NO. SI 62-006

Austro Engine Mandatory Service Bulletin No. MSB-E4-022/1
ATA-Code: 71-00

MANDATORY SERVICE BULLETIN

No. MSB-E4-022/1
SUPERSEDES MSB-E4-022

Figure 4: Waste Gate Circlip

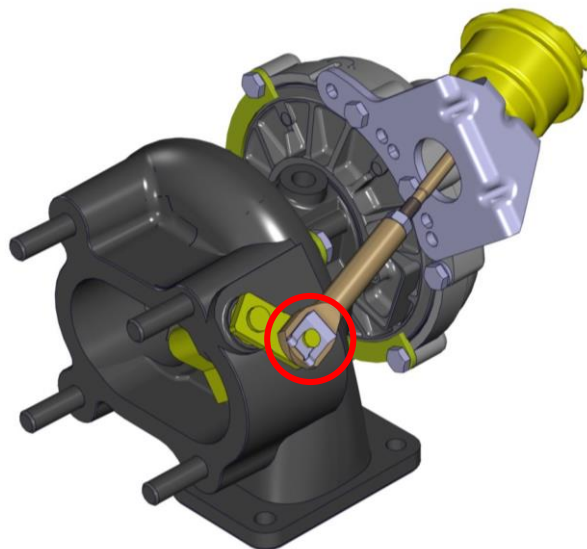
3. For waste gate controllers with markings as identified under 2. replace the waste gate controller with a waste gate controller not marked as listed under 2. according to Maintenance Manual section 81-00-33.
4. If MSB-E4-024/1 or RSB-E4-024 is not installed, replace the circlip DIN6799-5 with the spring loaded circlip E4A-41-100-801. For removal and installation refer to Maintenance Manual E4.08.04. Refer also to figure 4
